**FORD**  
**TRACTORS & EQUIPMENT**

**1983**

**SERVICE BULLETINS**

# **Service Bulletin**

**Figure 1  
Clutch Adjustment**

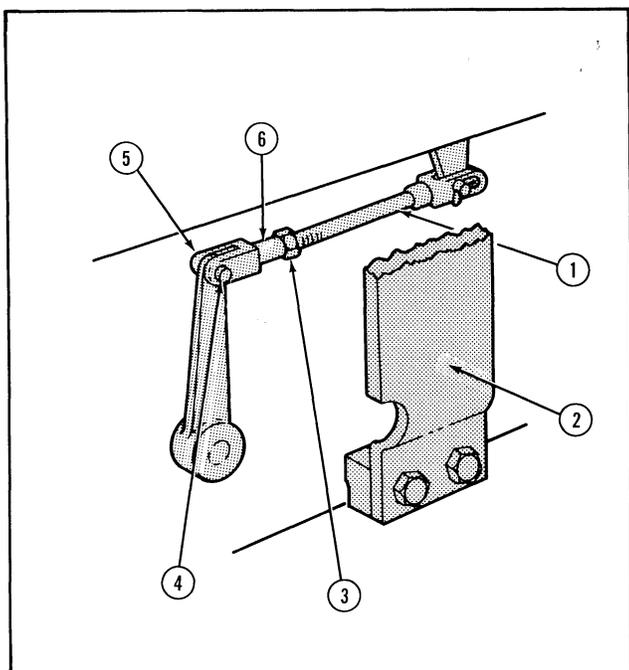
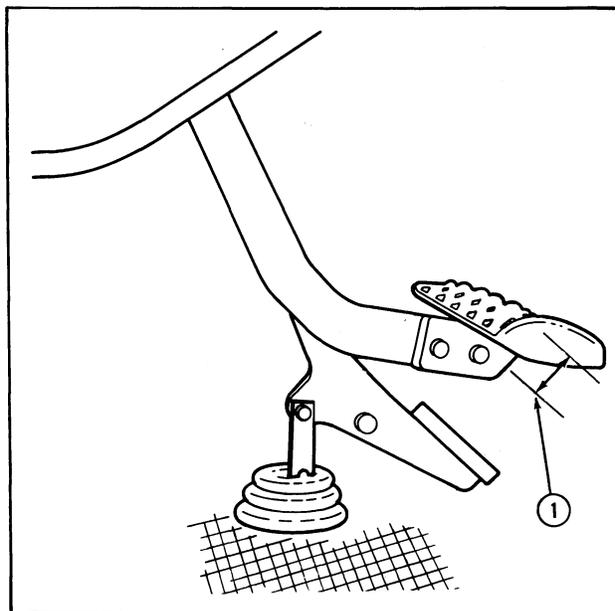
The clutch adjustment procedure for the Ford 6710 and 7710 is not shown in the Operator's Manual for the current tractors. In addition, the procedure in Repair Manual SE 3870, Part 4, Chapter 1, page 4, is incorrect.

Correct clutch pedal free play on these tractors is obtained by adjustment of the horizontal clutch rod as follows:

- Referring to Figure 1, loosen the locknut (3) and remove the split pin (5) and the clevis pin (4).

- Turn the clevis (6) to lengthen or shorten the rod (1) until clutch pedal free play, Figure 2, is 1.25 to 1.50 inches (31.75 to 38.1 mm).

**Figure 3**  
**Gearshift Rod Sleeve**

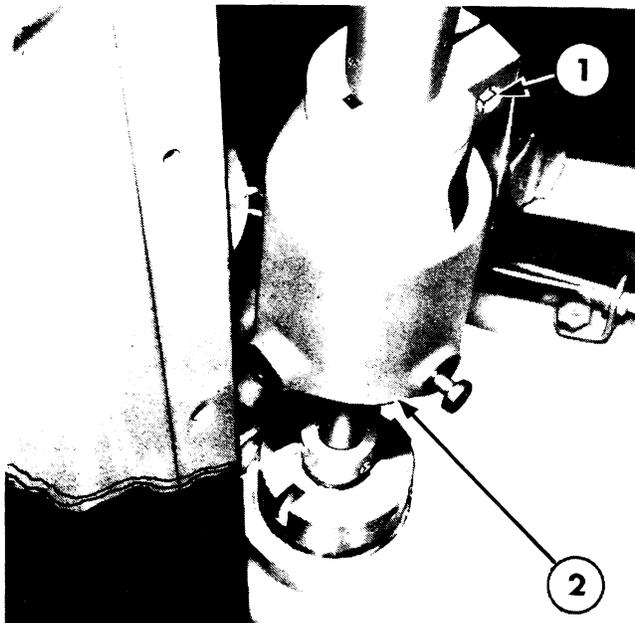
A few instances of gearshift sleeve clamp bolt loosening have been reported on Ford 5610, 6610 and 7610 tractors with synchromesh transmissions. To prevent this condition use the following procedure:

- Remove the clamp bolt from the sleeve, Figure 3.
- Thoroughly clean the threads of the bolt and the sleeve.
- Apply a thread sealant, Ford Automotive Part No. E0AZ-19554-A (.2 oz. container) to the bolt threads.
- Replace the bolt and tighten to a torque of 18 lbs. ft. (24.5 Nm).

**Figure 1**  
**Inner Connector**

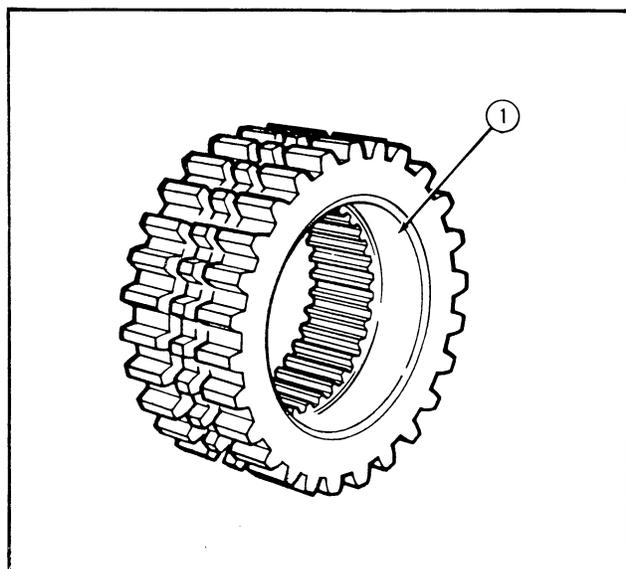
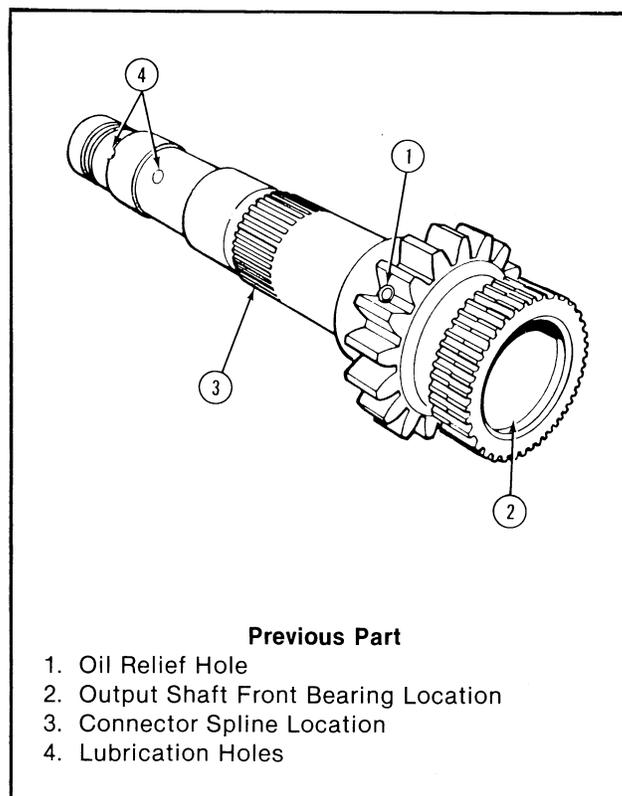
The transmission countershaft and coupling assembly and the countershaft inner connector have been modified effective with transmission date code 2D23B (4-23-82). These modifications consist of:

1. The new inner connector has a non-splined pilot to prevent wear on the thrust bearing, Figure 1.
2. The mating countershaft splines have been reduced in length to accommodate the non-splined pilot, Figure 2.
3. Two lubrication improvements have been introduced to the countershaft as follows:

**Figure 2**  
**Countershaft**

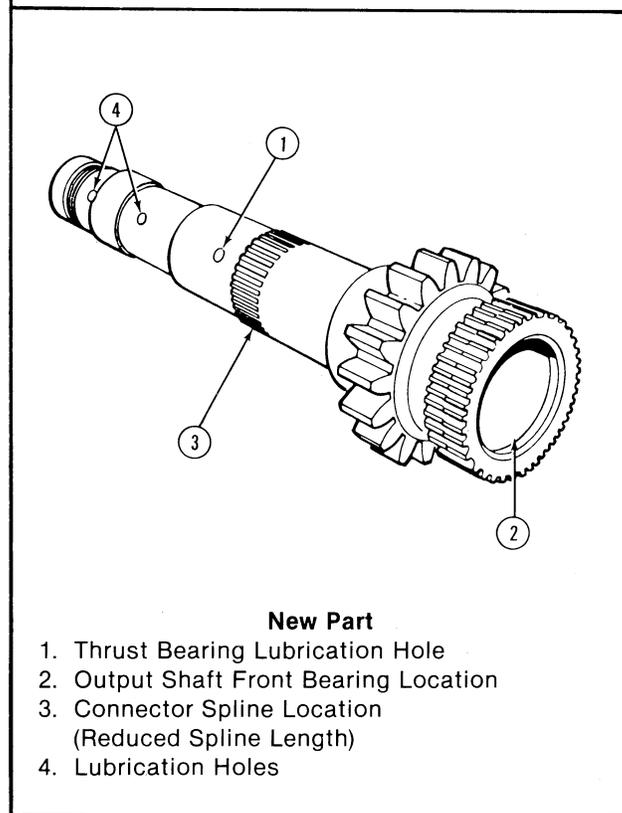
- The relief holes in the gear at the end of the countershaft, Figure 2, have been deleted, increasing the oil flow to the output shaft front bearing.
- To increase oil flow to the new countershaft, the drain hole has been deleted from the transmission hub support plate, Figure 3.

Because of the revisions to the connector and the mating countershaft splines, the two parts must be replaced in service as matched sets. When installing the new inner connector, be sure the pilot end is installed first, facing the rear of the countershaft.

Whenever attempting any repairs requiring disassembly of these transmissions, plug the drain hole in the support plate. In addition, if the previous countershaft is not replaced during these repairs, plug the oil relief holes in the rear gear shown at arrow (1) in the upper frame of Figure 2.

**Figure 3  
Hub Support Plate**

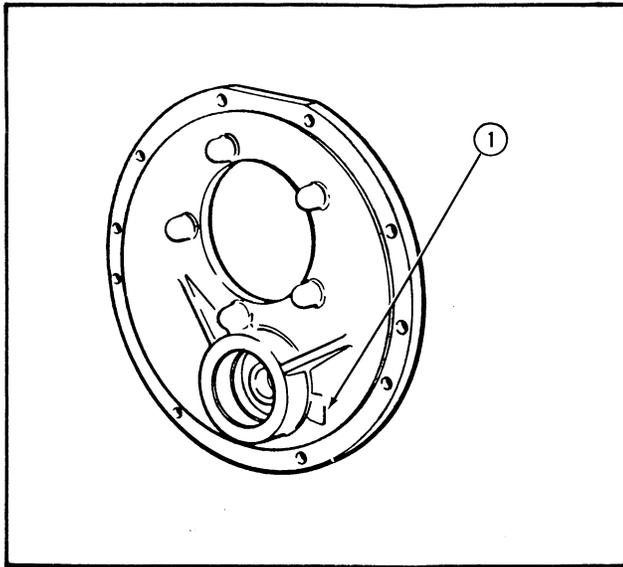
Whenever installing the new parts to a transmission built prior to date code 2D30B, plug the drain hole in the support plate, Figure 3, by brazing. This will provide lubrication to the output shaft front bearing.

Figure 4

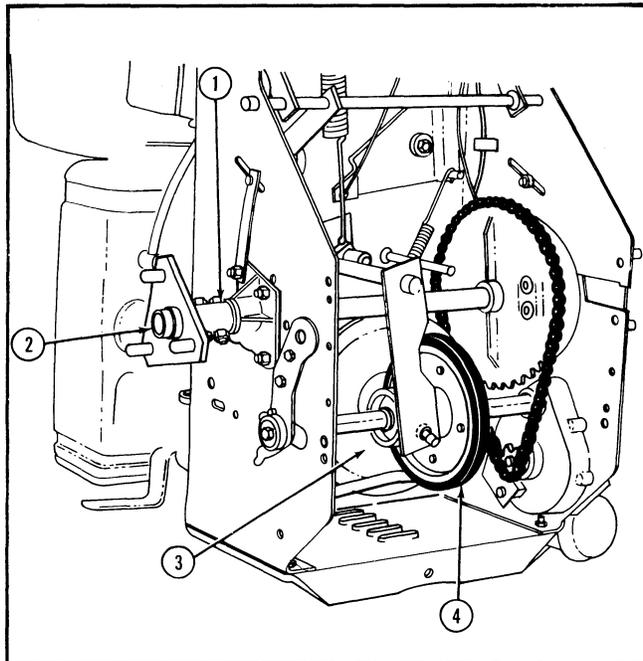
Remove and replace the rubber faced drive wheel Figure 4, as instructed on page 18 of the RMT Repair Manual, SE 3988.

**IMPORTANT:** When the drive wheel is removed, inspect the drive disc, JAC 992270 (Figure 4). If excessive wear of the rubber on the drive wheel has resulted in metal to metal contact with and damage to the drive disc, the disc also should be replaced with a new disc JAC 992230. Refer to instructions on page 22 of the RMT Repair Manual, SE 3988. (**NOTE:** The retaining bolt which holds the drive disc to the crankshaft should be tightened to 20-24 lbs. ft.)

Install the new bearing retaining ring, JAC 994460 (See Figure 4) on the R.H. axle bearing as follows:

1. R.H. drive wheel should already have been removed to replace drive wheel.
2. Remove two (2) 5/16"-18 x 1-1/2" hex head bolts from R.H. axle tube assembly - See Figure 4.
3. Remove R.H. axle tube assembly from axle shaft.

Figure 5

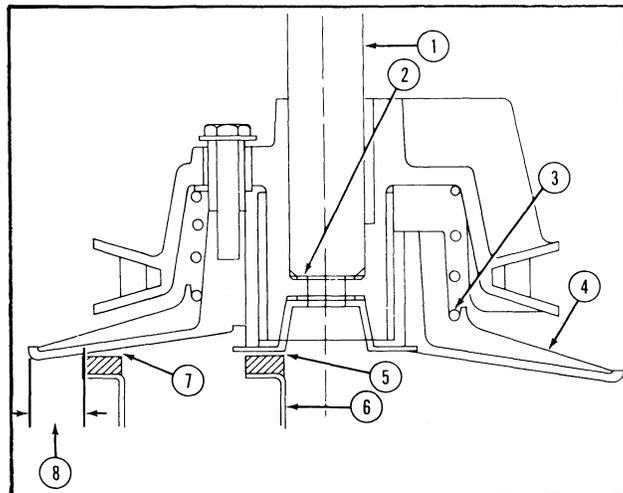
After the new drive wheel has been installed, adjust the wheel to drive disc clearance as shown in Figure 5 and described below.

5. Adjust the rubber drive wheel to drive disc clearance to .020-.040" with the wheel slightly past the edge of the disc retainer cup or recess. This makes it easier to measure the clearance accurately. See Figure 5.

- a. Clearance improperly adjusted with shims. Should be .020-.040".
  - b. Washer between end of engine shaft and engine pulley (See Figure 5) prevents proper adjustment and free travel. Remove and discard washer, then readjust disc to wheel clearance to .020-.040".

8. Adjust drive pedal traction rod so that when pedal is full forward, the drive wheel is approximately 1 to 1-1/4" from the outside edge of the drive disc. See Figure 5.

**Figure 6**

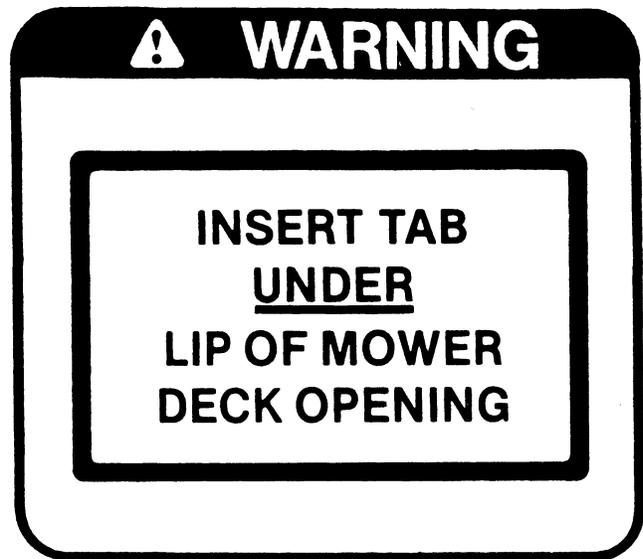
The new deck cover decal, JAC 990147, contains important operator information regarding installation of the cover to assure proper contact and function of the cutter deck safety switch, JAC 181968.

Install the decal on the deck so it is close to the safety switch and readily visible to the operator.

Figure 7

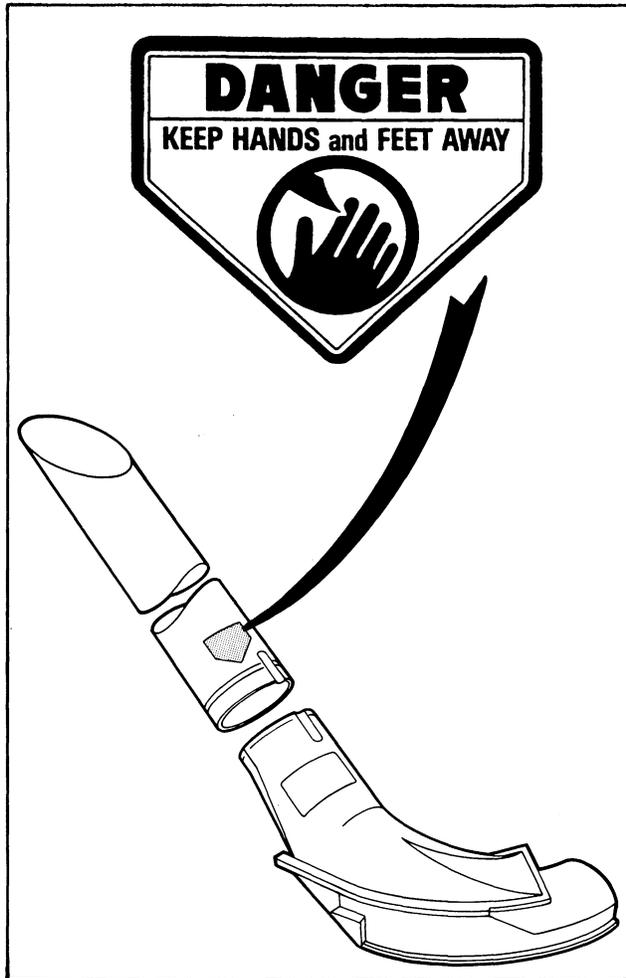
For all Rider Mowers equipped with the optional grass catcher, an existing DANGER decal, JAC 339460 should be installed on the grass chute so that it is clearly visible to the operator. See Figure 7.

Figure 8

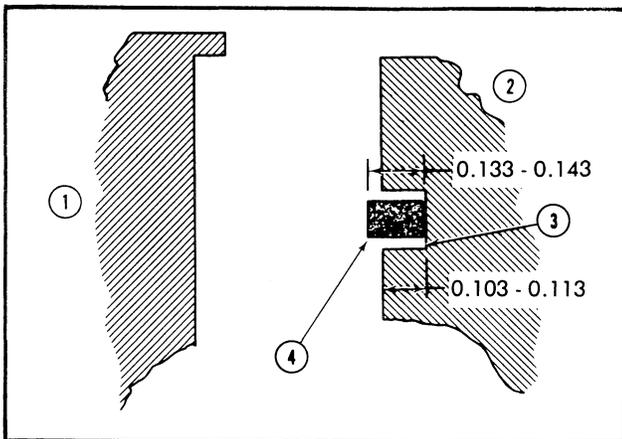
Sealing D8NN-7A248-AA used on the converter pump has a rectangular cross section of 0.113/0.123 by 0.133/0.143 inch (2.87/3.12 by 3.38/3.63 mm). The accommodating groove in the converter pump is 0.103/0.113 by 0.160/0.170 inch (2.62/2.87 by 4.06/4.32 mm) wide; therefore the sealing can be installed in two ways.

To provide adequate sealing, the sealing must be installed with the wider dimension up, as shown in Figure 8. When installed correctly, the sealing will have a loose fit in the groove.

Apply adequate petroleum or low temperature grease to the seal to retain it in position during assembly of the converter cover.

Figure 9

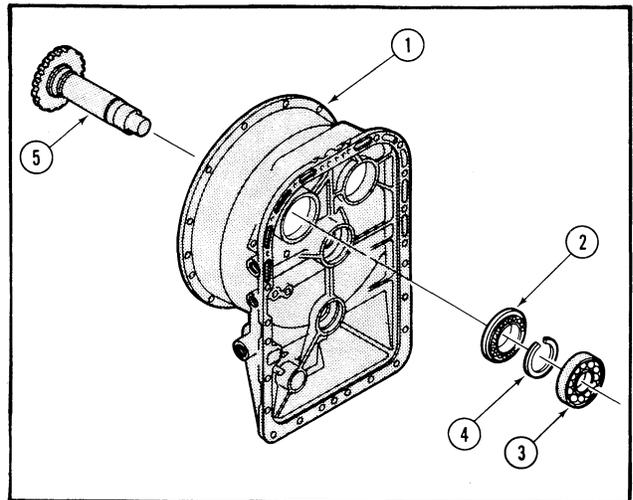
Failure of the Oil Pump Drive outer bearing has been experienced in the field on A64 and A66 wheel loaders. To correct this concern, a new heavy duty bearing is now available in service. This bearing may also be used to service the A62 wheel loaders. The new bearing features rollers as opposed to balls in the previous part, which is no longer serviced.

The new bearing is to be incorporated in production on the A62, A64 and A66 wheel loaders, effective with transmission date code 3A01 (January 1, 1983). The new bearing is identified as follows:

Figure 9 shows the location of the new bearing.
